Subject: STRUCTURAL MODIFICATIONS FOR THE GENERAL ELECTRIC TEST REACTOR -
DOCKET 50-73

RESPONSES TO NRC REQUEST FOR INFORMATION BASED ON
GETR SITE VISIT HELD 18 JUNE 1979

FFS WATER SUPPLY RESERVOIRS

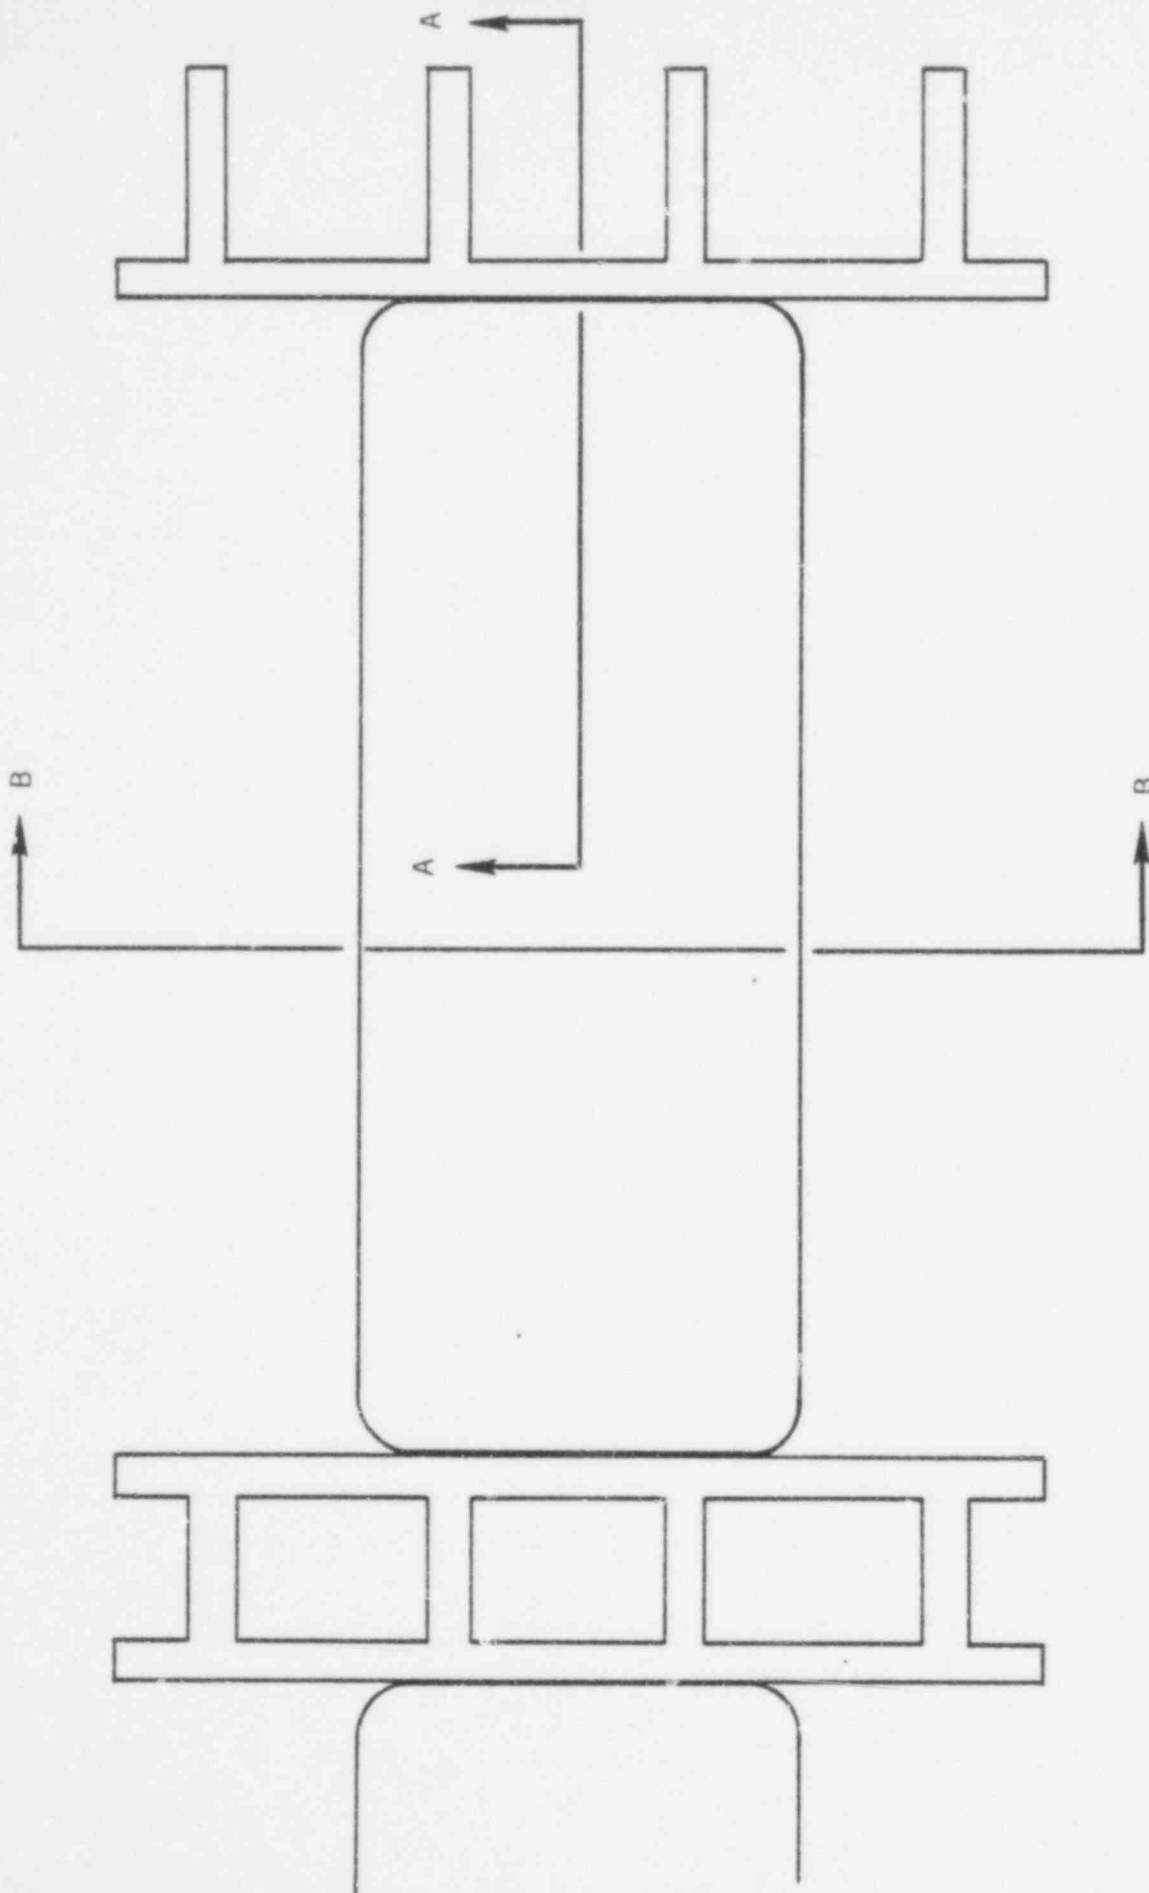
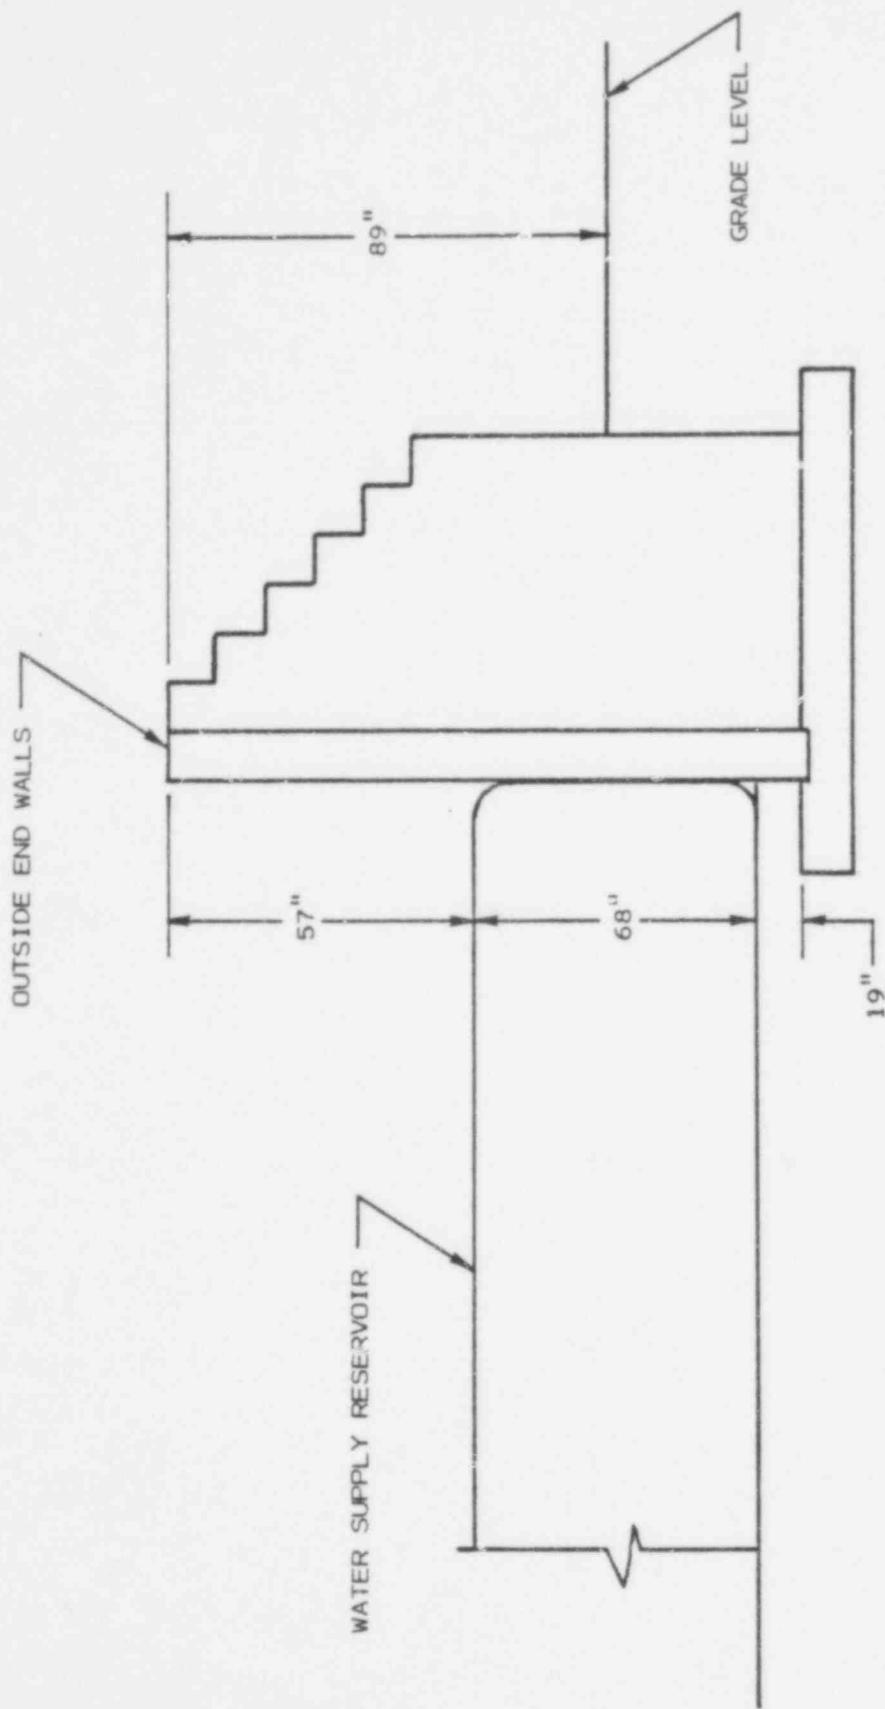
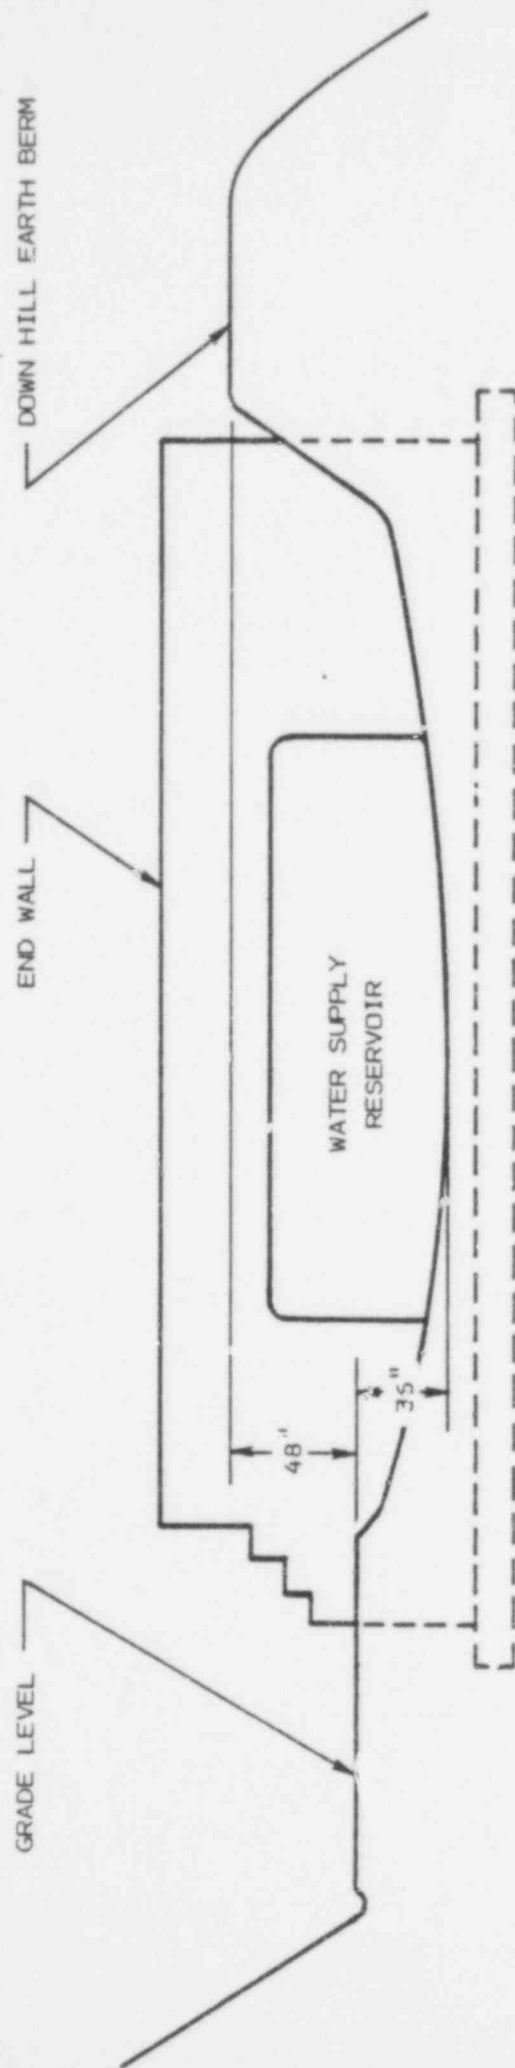
Provide the height above finished grade of the tops of the walls surrounding the water bladders for the fuel flooding system.

Figure #1 (three views) provides the orientation and dimensions of the FFS water supply reservoirs with respect to grade level and adjacent walls.

FFS SURVEILLANCE INSTRUMENTATION

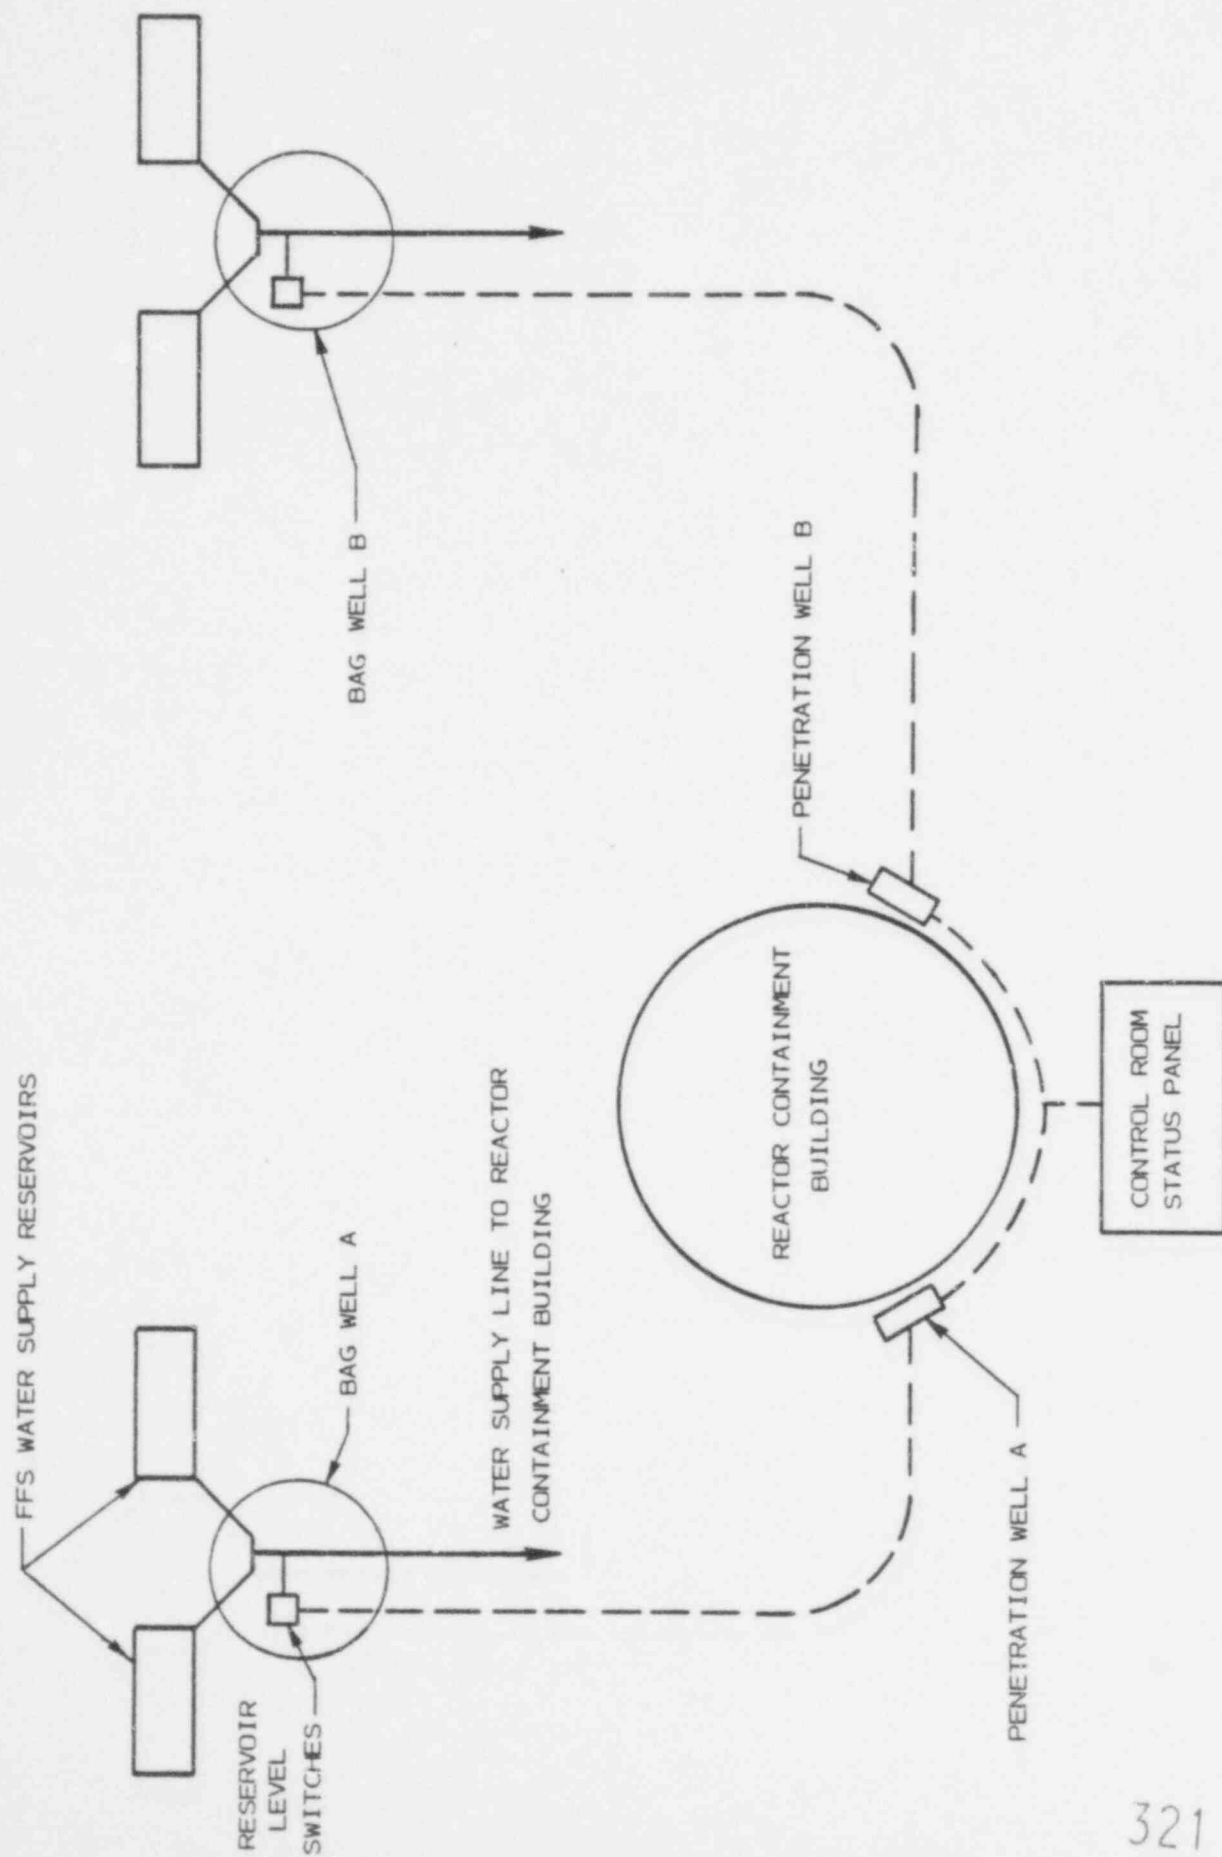
Provide complete details of the automatic level sensing system for the fuel flooding system. Include a discussion of the confidence that can be placed on the functioning of this detection system and the basis for this confidence.

The level sensing system collects, checks, transmits, receives and displays bag (reservoir) level data. The physical layout of the fuel flooding system (FFS) surveillance instrumentation is shown in Figure 1. The elementary diagram is shown in Figure 2. Data on level switch status goes to the "Data Collector" located at each bag well and is transmitted through a similar "Data Collector" (located at the "penetration wells" adjacent to containment building) to the "Control Room Status Panel" in the reactor control room.

HOSE PULL TEST
FIGURE 1.

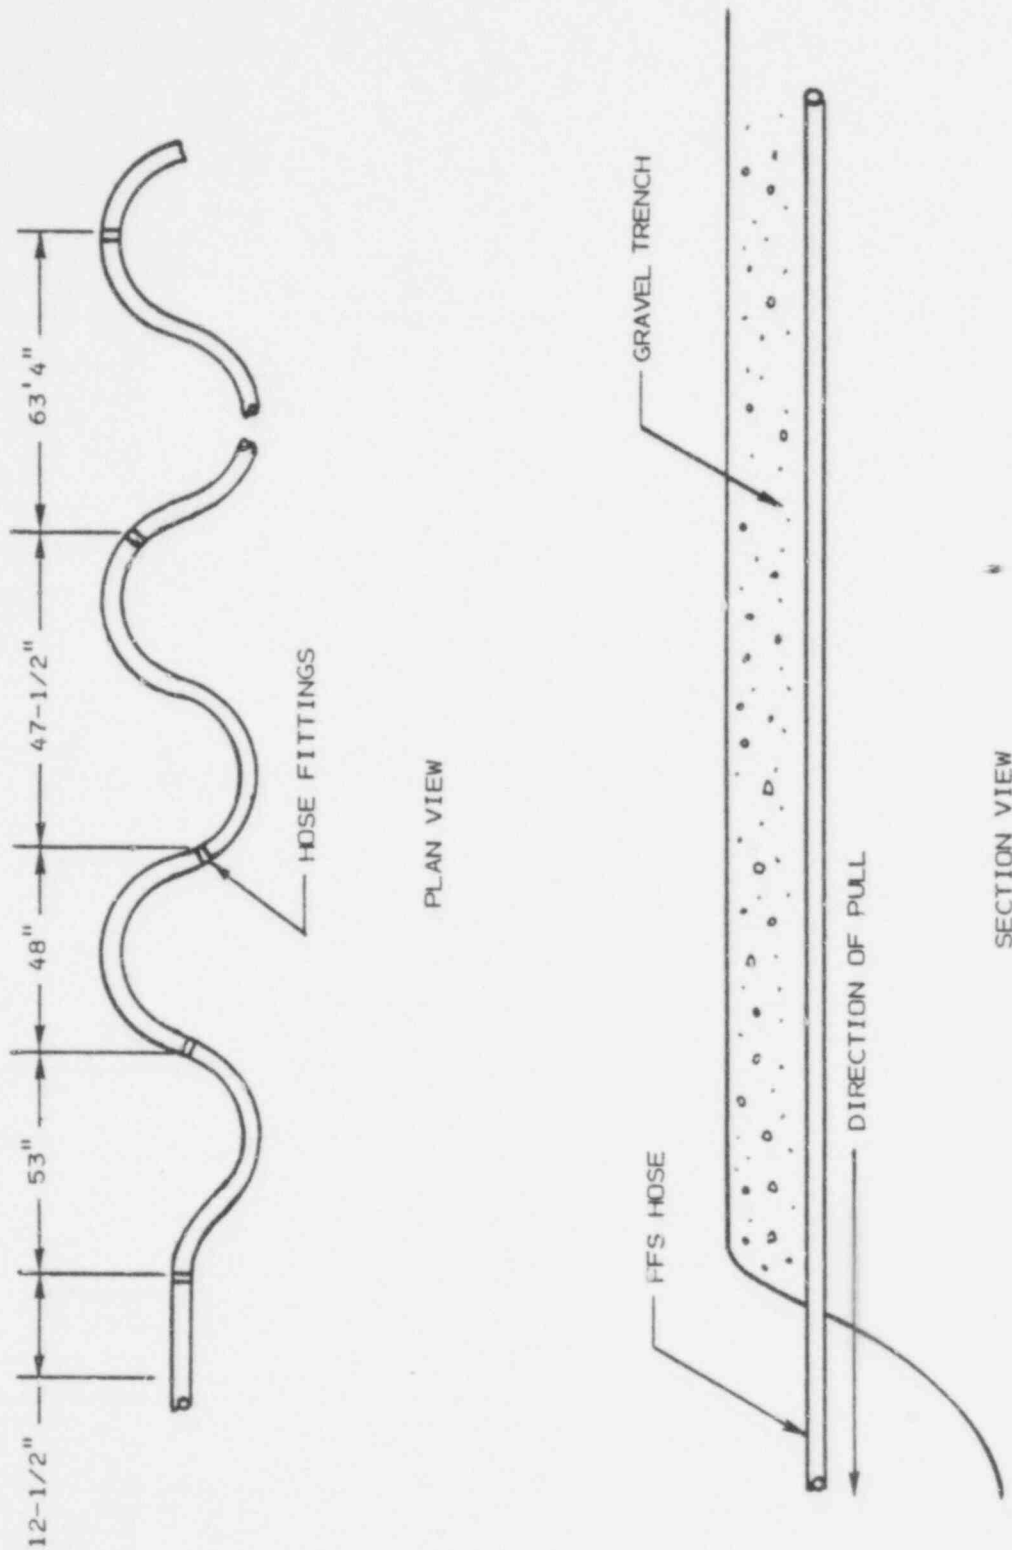
Provide information on all tests which have been conducted on the FFS supply line hoses.

1. Hose Pull Test - The Hose Pull Test was conducted by burying a hose assembly (i.e., hose and fittings) in a trench approximately 80 foot long. The burial specifications corresponded to the specifications on the installation print.

The hose assembly was then pulled through the trench. (See Figure 1) Note that this procedure is a more conservative test of the strength of the hose than pulling the hose up out of the trench (which may occur during postulated surface rupture offset). The hose assembly was pulled a total distance of five meters. The assembly was then visually inspected and hydrostatically tested at the design pressure. There were no indications of any damage and the assembly passed the hydrostatic test with no indication of leakage.
